REMARKS

FIG. 31

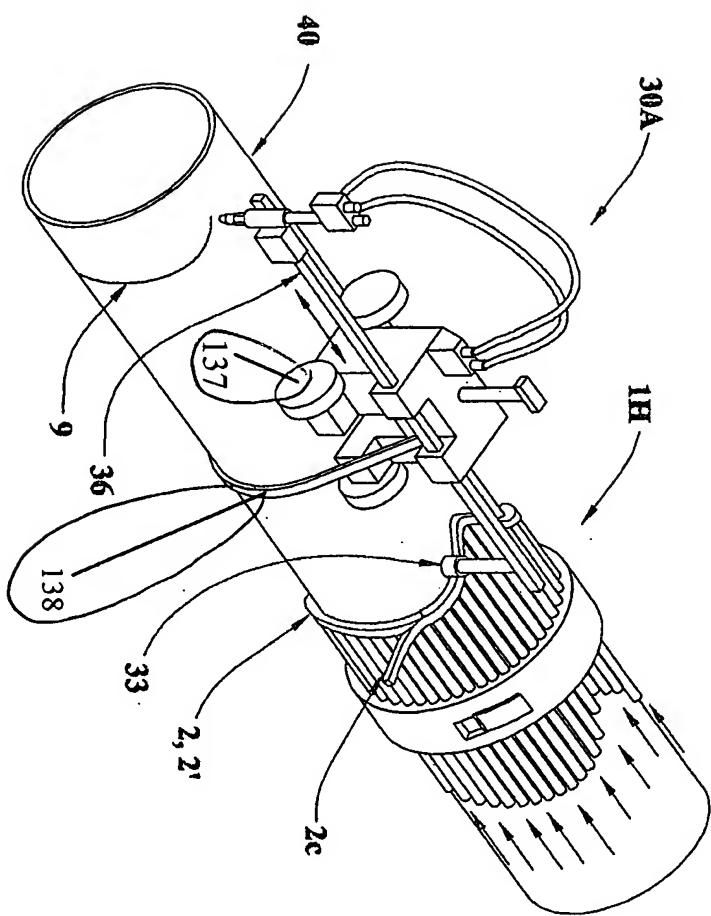
The examiner objected to claims 22 and 31 for failing to provide a proper antecedent basis for “a chain and wheels” in the specification.

Figure 31 shows the chain and wheels described in claims 22 and 31. Page 19 of the specification has been amended to add the wheels and chain to the specification. Figure 31 has been amended to add reference numbers for the wheel and the chain. A replacement page for Fig 31 is attached with the corrections shown in red.
